# Review Report: Building C-400 Thermal Treatment 90% Remedial Design Report and Site Investigation, PGDP, Paducah Kentucky

15 August 2007

Dr. Brian Looney, Savannah River National Laboratory: Review Technical Lead

**Figure A3 – MIP Boreholes and ECD response overlaying interpolation of PID responses in the Southeast Source Zone area (looking North).**

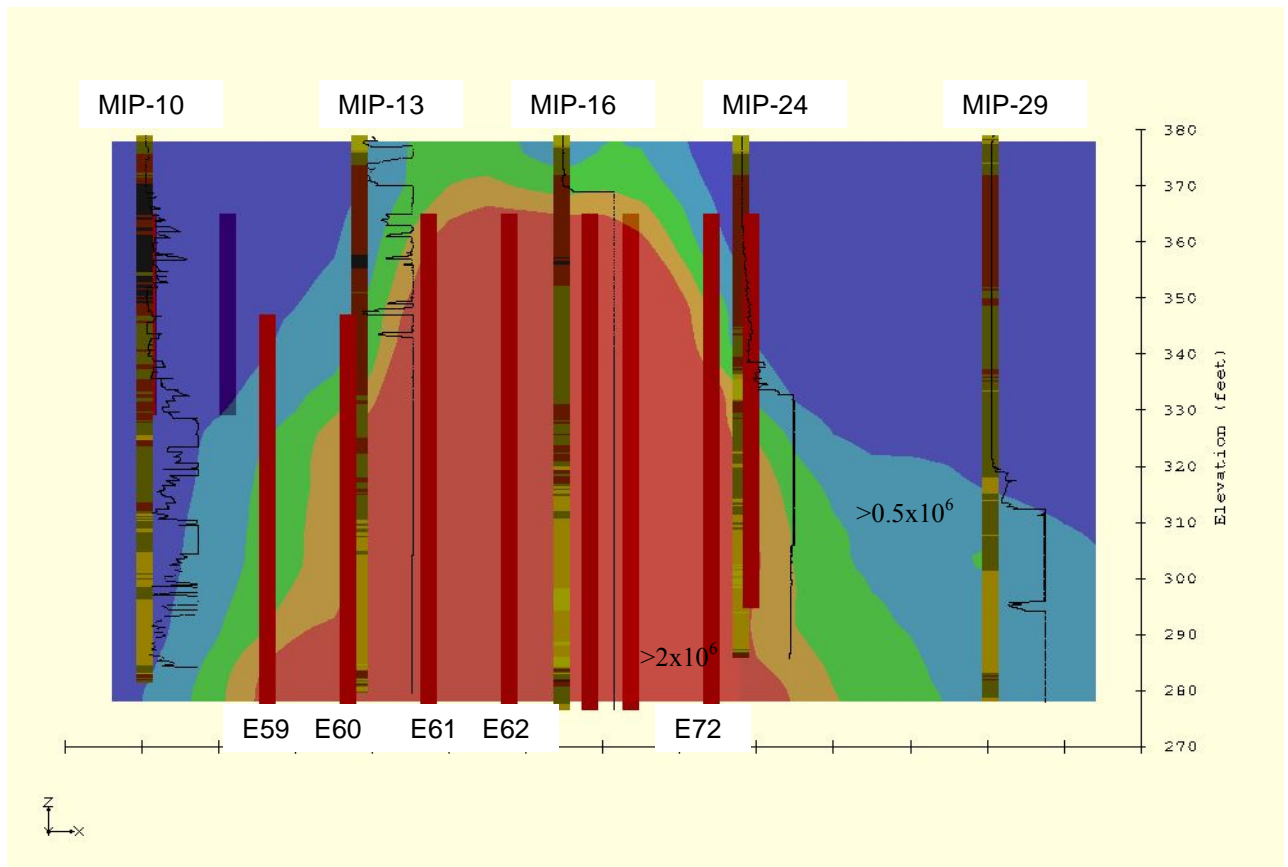
Figure A3 is a cross-section from the C-400 southeast source zone region where the color filled contours represent an interpolation of the MIP PID data. The red color represents responses greater than  $2 \times 10^6$  uV and the light blue are responses between 1 and  $0.5 \times 10^6$  uV. Overlaying the contours are MIP borehole logs where the black line associated with each MIP borehole is the discrete depth ECD responses in uV. Also shown are the proposed locations of ERH electrodes indicated as red columns.

Since no confirmation soil or groundwater samples were collected from the MIP boreholes, the PID responses associated with neat TCE (i.e., TCE NAPL) are unknown. However, there were two other detectors used to analyze the gas stream collected by the MIP including the FID and ECD. While the FID responses were similar to that of the PID (not shown), there appears to be a relationship between the interpolated PID values to the ECD responses as shown in Figure A3. For example, the PID response from MIP29 between 68 and 76.6 feet bgs (311 and 302 feet elevation) was greater than  $2 \times 10^6$  uV and the ECD detector was at the maximum response of  $1.3 \times 10^7$  uV in this region as well. The similarity between the maximum ECD and PID responses that suggested the presence of neat TCE are also evident in the MIP13, MIP16, and MIP24 results. Why the thermal treatment volume was not extended 80 feet to the east to encompass the MIP29 location, where there were a few PID responses greater than  $9 \times 10^6$  uV PRS DNAPL value near 75.7 feet bgs, is unclear.

**Figure A4 – MIP Boreholes and ECD response overlaying interpolation of PID responses in the Southeast Source Zone area (looking West).**

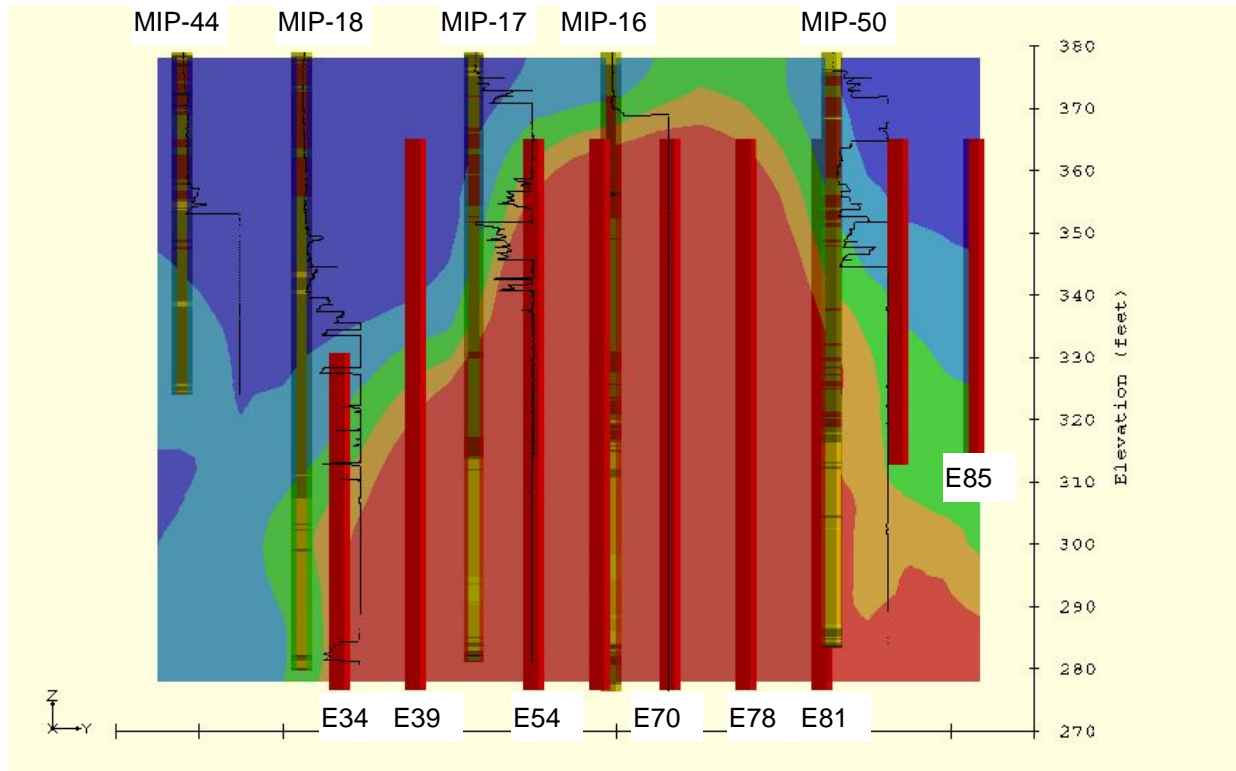
Figure A4 shows that the ECD response and PID interpolations suggest contaminant levels that may indicate the presence of neat TCE to the south of MIP18. However, since MIP44 only extended to 55 feet bgs, there is insufficient data to support the assumption that MIP18 defined the southern most limit of neat TCE. North of MIP50, the treatment volume extends to 66.3 feet bgs while there is the potential for neat TCE to be present at depths of up to 104 feet bgs based on the PID interpolations and the ECD response from MIP50.

Figure D1. Estimated Electrode Radius of Influence in the Saturated Zone

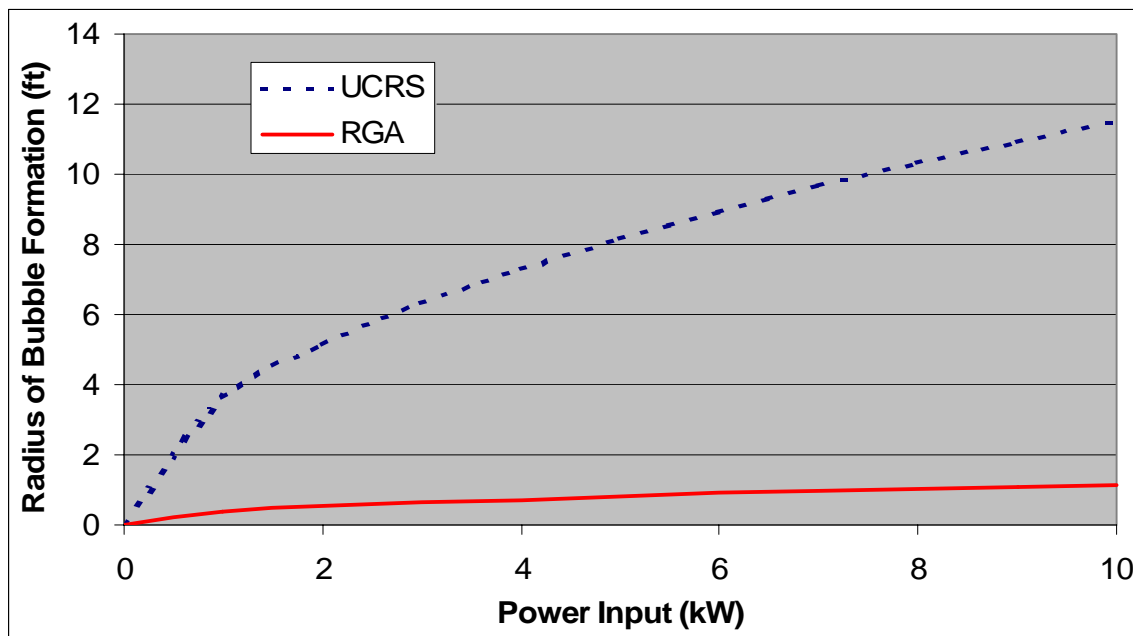
Values to estimate the radius of the zone of bubble formation around the electrodes in the saturated portions of the UCRS and the RGA utilizing equation (5) are provided in Table 1. The radii are plotted in Figure 1 as functions of the input power to the electrode. The electrode power is approximately 6,800 kW and, as indicated, the UCRS is expected to have a bubbling radius close to 10 feet. However, the high permeability of the RGA yields a radius less than 2 feet. These calculations are conservative because the model does not account for the somewhat uniform heating of the electrical power and lateral heat conduction. This simplistic model is most applicable at the bottom of the RGA since the top of the RGA is bounded by the lesser permeability of the UCRS. Hence, the results are cause for concern that heating the bottom of the RGA to steam temperatures may not be feasible. The influx of cool water replacing volatilized water will be very rapid and the energy requirements for heating very large. Extending electrodes into the top of the McNairy formation provides a good opportunity to extend the zone of bubble formation but replenishing the water in the McNairy pore space to prevent drying out may limit this effect.

This discussion on steam bubble formation does not imply that significant contaminant mass removal will not occur – even at the bottom of the RGA. The ERH pilot test achieved good results without such heating. Rather, the ITR team encourages a clear understanding of this issue and incorporate any results to avoid setting a heating metric that may not be achievable even when the primary objective of mass removal is realized. Further, the simplified calculation is not offered as a definitive method for electrode spacing. The ITR team supports the PGDP team approach of using a numerical model for the actual design. The simplified “radius of steam bubble formation” calculation emphasizes the importance of reducing uncertainties and assuring the conceptual basis of that numerical modeling.

Figure D2. Estimated Shape of the Steam Injection Front in the RGA

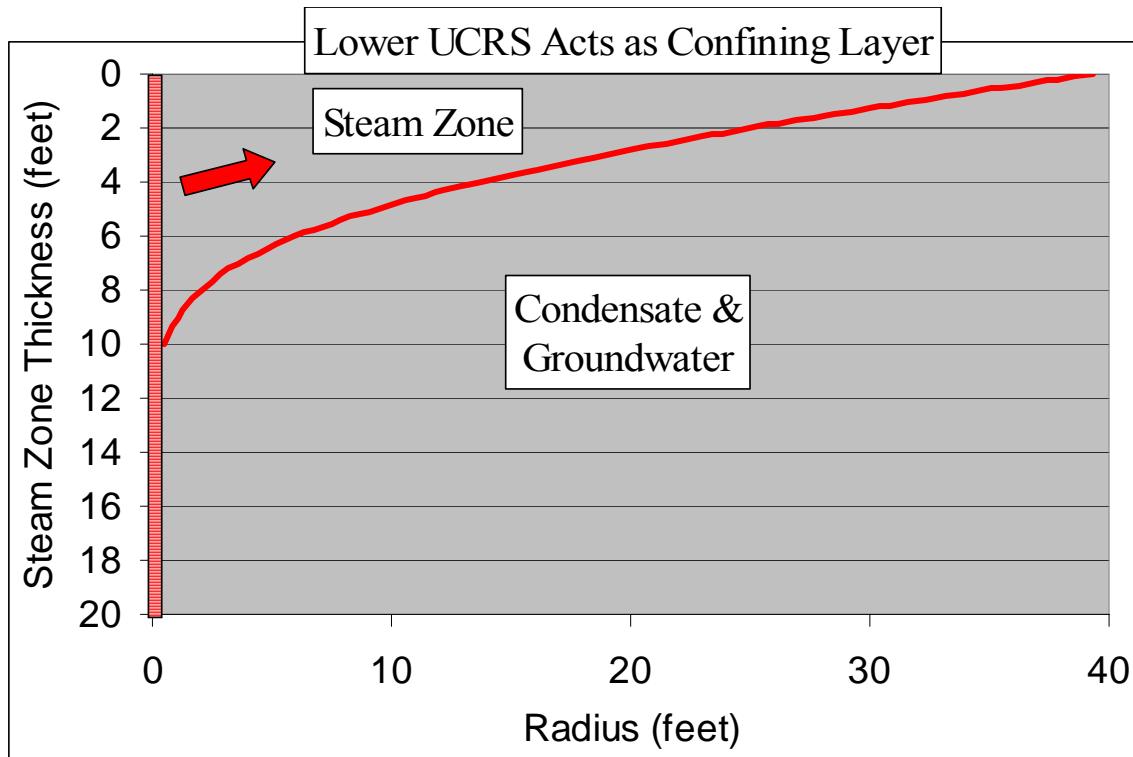
The shape of the steam front resulting from injection of steam into the RGA at the design rate of about 2,000 pounds per hour was estimated utilizing the model of van Lookeren (1983). The result of the calculation is illustrated in Figure 2. The steam zone exists around the injection well only above the red line and liquids exist below. This plot suggests that the bottom of the RGA will not be significantly heated by steam injection. Any DNAPL in this region will not be displaced and recovered. Further, attempts to mitigate this effect by screening deep in the RGA would not be successful as buoyancy and the path of least resistance would bring the steam zone to the top of the RGA before

lateral growth could be achieved deep in the RGA. The recommendation is to eliminate the steam injection activity and verify the area requires treatment before proceeding with any remedial action in this previously treated volume.
